*Sterling Development  
Group Subdivision  
Canterbury, Connecticut*

**Environmental Review Team Report**

**for the  
Inland Wetlands and Watercourses Commission  
Canterbury, Connecticut**

**December 2000**

## Location Map and Lot Layout

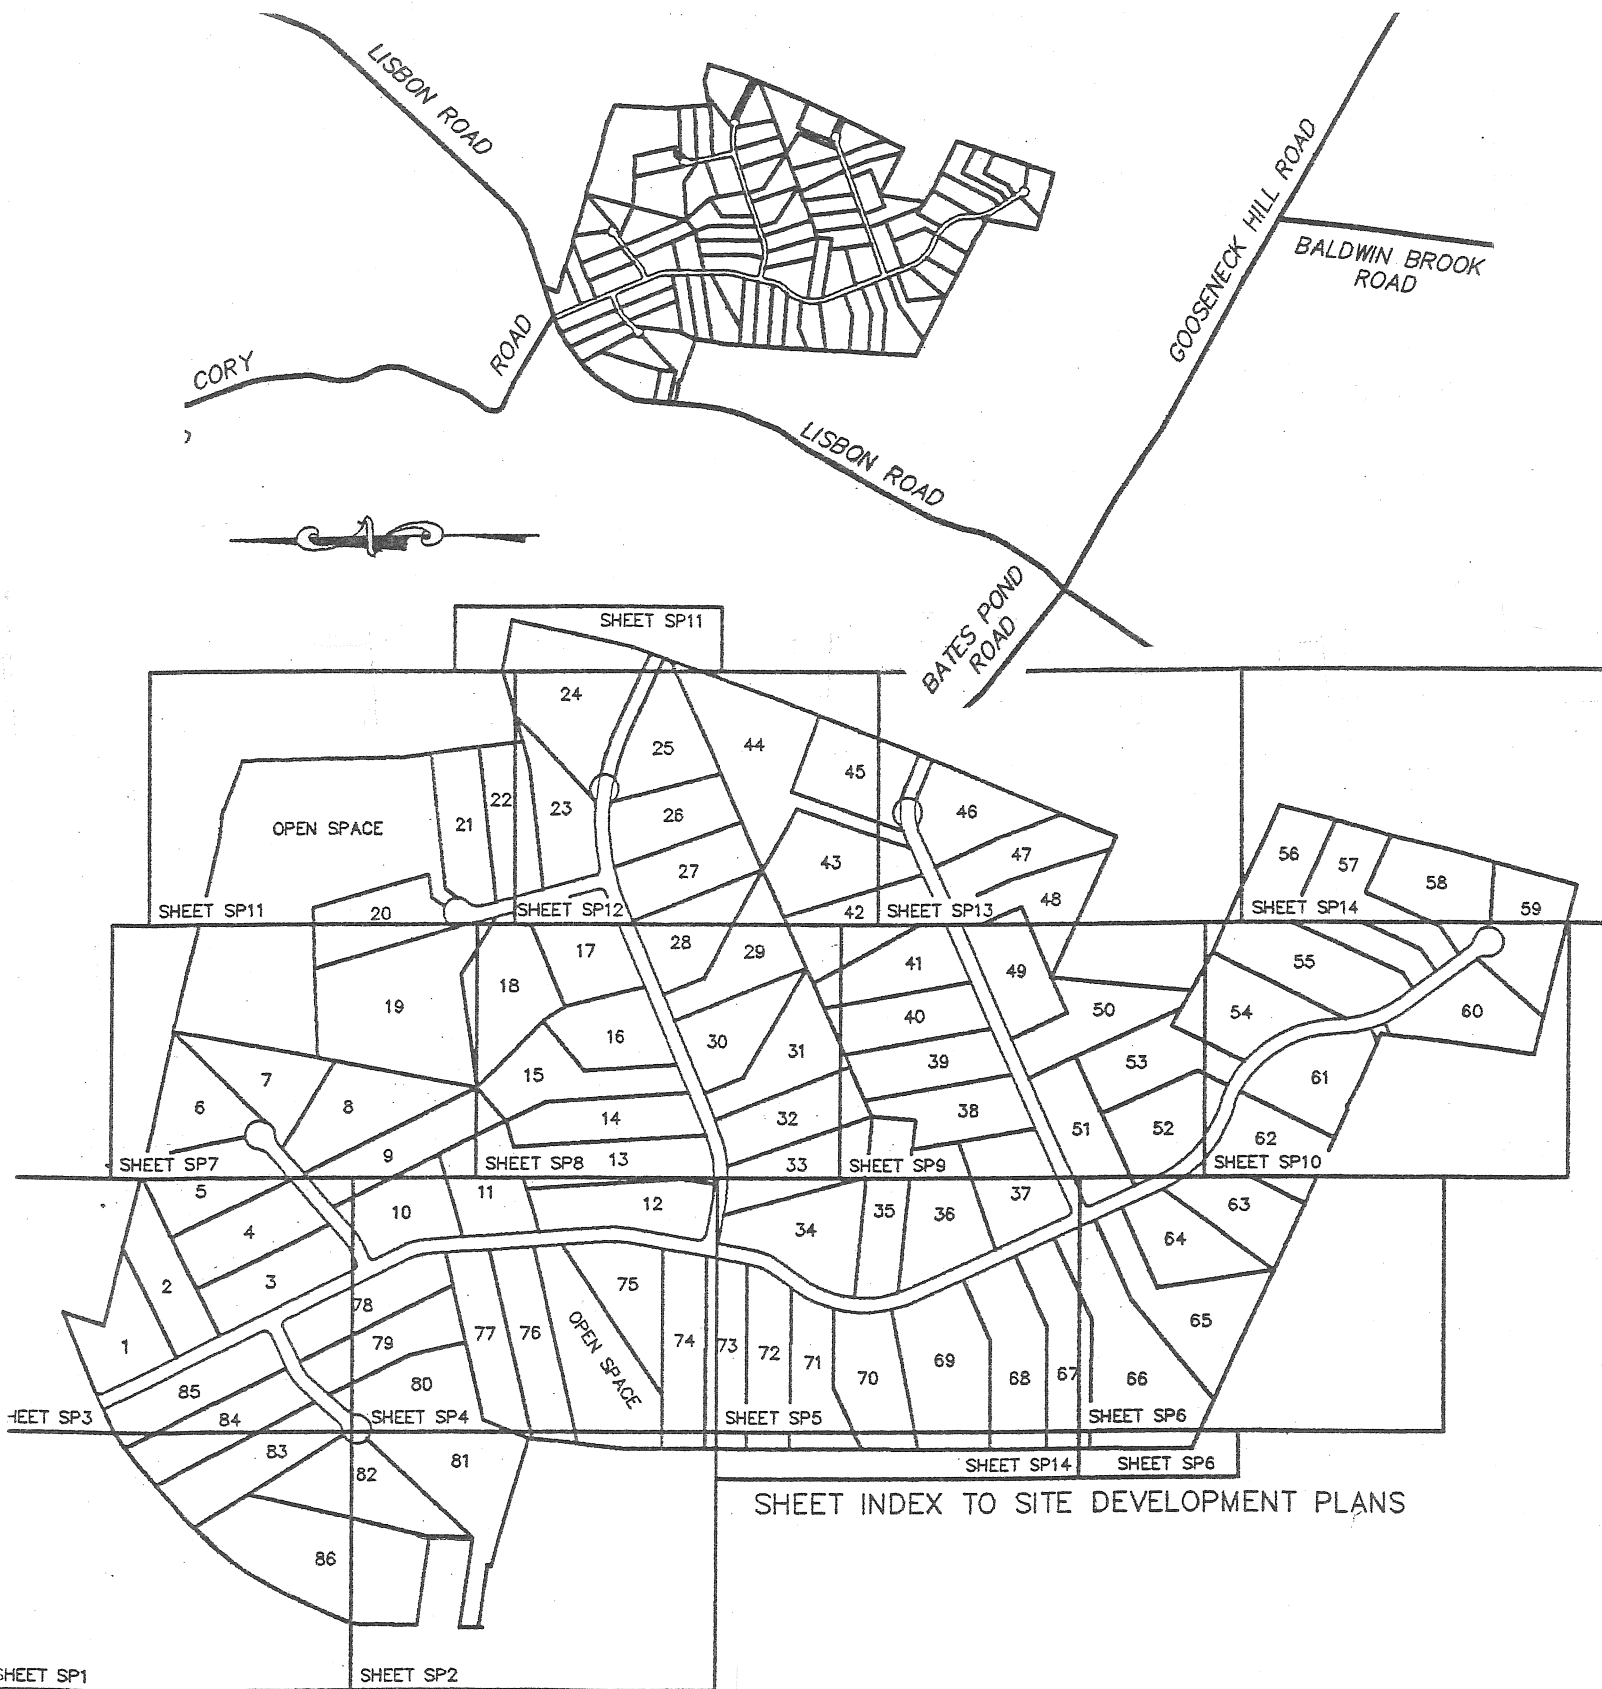
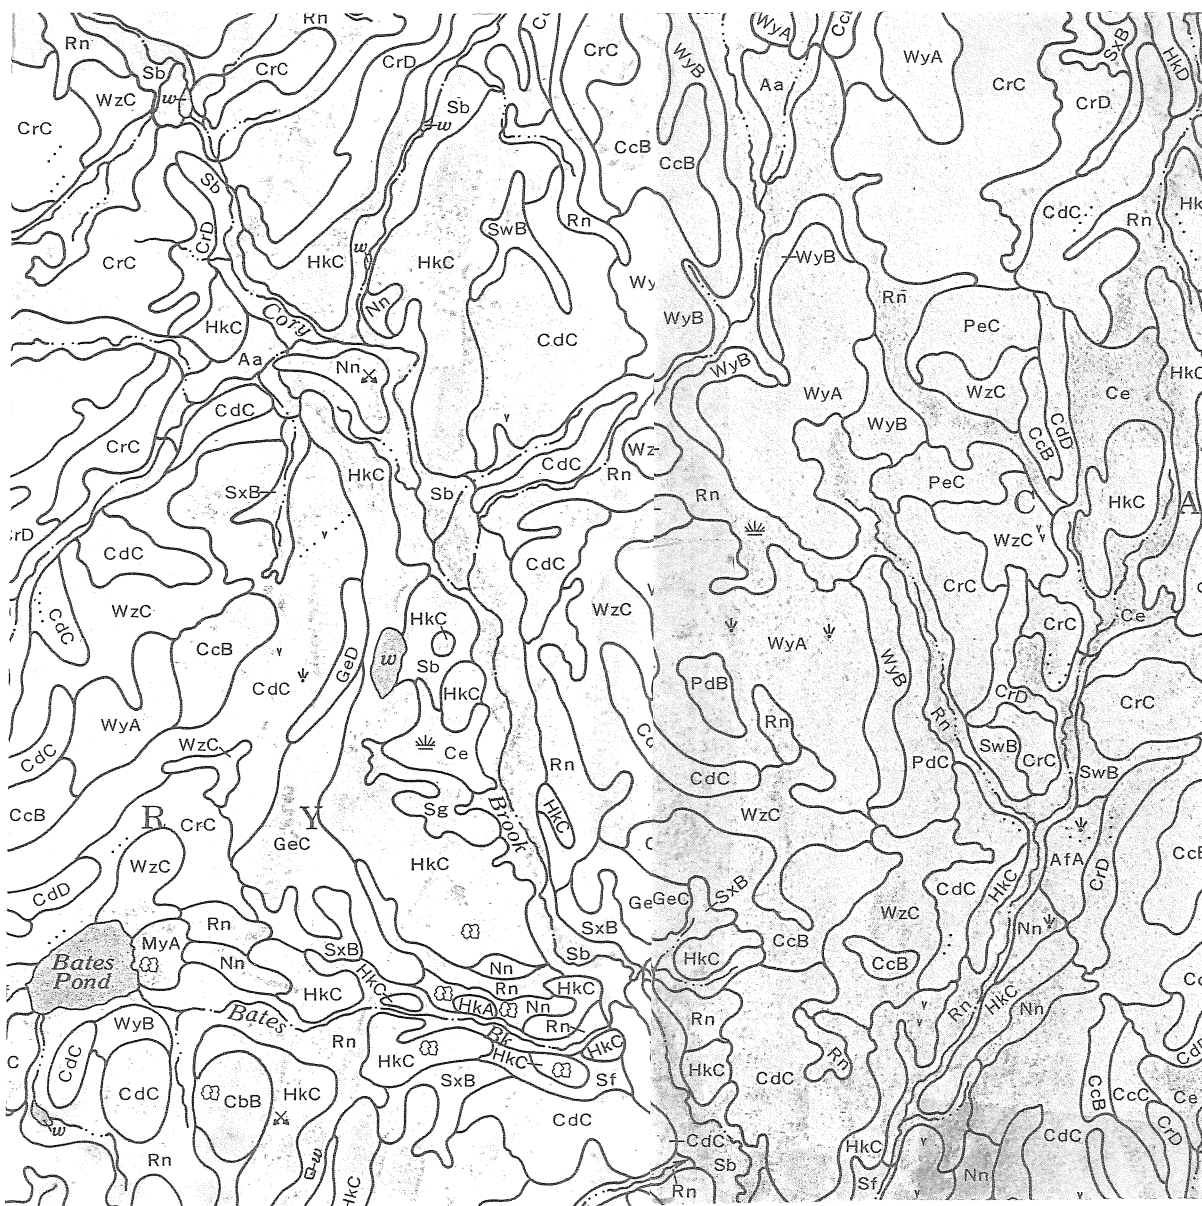
- 1) The Location Map is functionally unusable with regards to natural or cultural resource reviews. This map and the overall site plan have no descriptions of the overall hydrology/geology/topography or land uses or town zone districts (the latter is briefly addressed by listing the site as within the Rural Zoning District.) One suggested inclusion would be map delineation of the watershed divides within the Cory Brook sub-watershed and the location of the site superimposed on this map layer. The Town may desire additional relevant descriptive information from the applicant toward an effective site plan review.
